SUPPLEMENT TO UPDATE TO TECHNICAL DRAINAGE STUDY

Durango & Grand Montecito Multi-family Residential

BNN-21-001

UPDATE #1 to the Technical Drainage Study for Durango & Grand Montecito

FIGURE 8

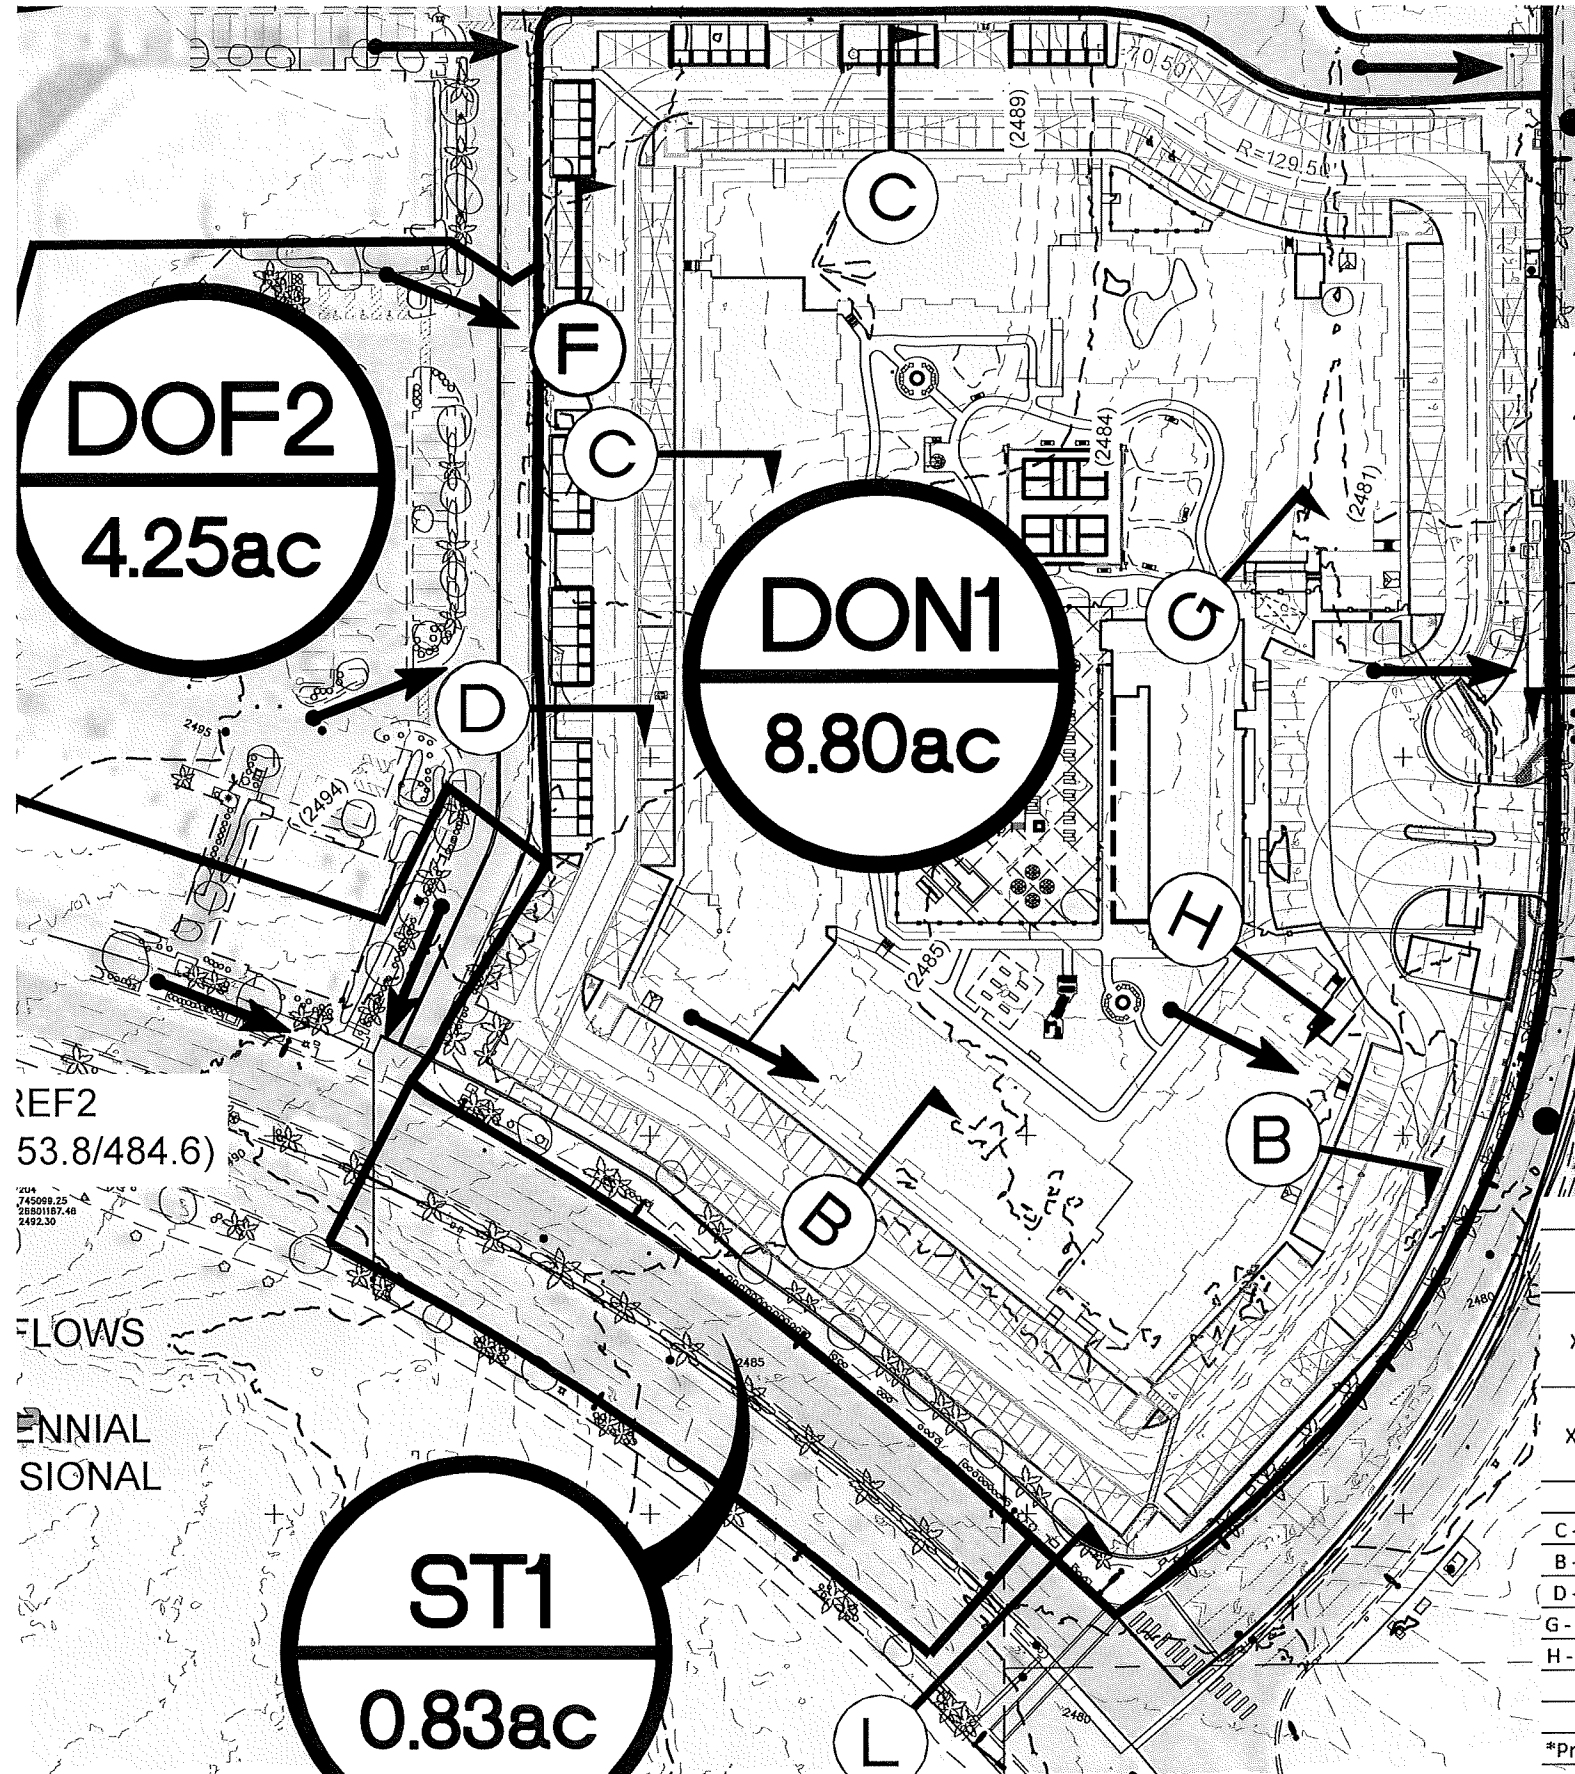
- 2. Clubhouse-N and Clubhouse-S listed in the summary table cannot be found anywhere in the grading plans. Clubhouse is the only related building found. Address and resolve in the next submittal.**

There is only one Clubhouse. Note: Courtyards North and South of the Clubhouse are affected by different flows and depths of flow, hence Clubhouse-N assesses the north side of the Clubhouse and Clubhouse-S assesses the south side. Both sides are protected per city of Las Vegas requirements.
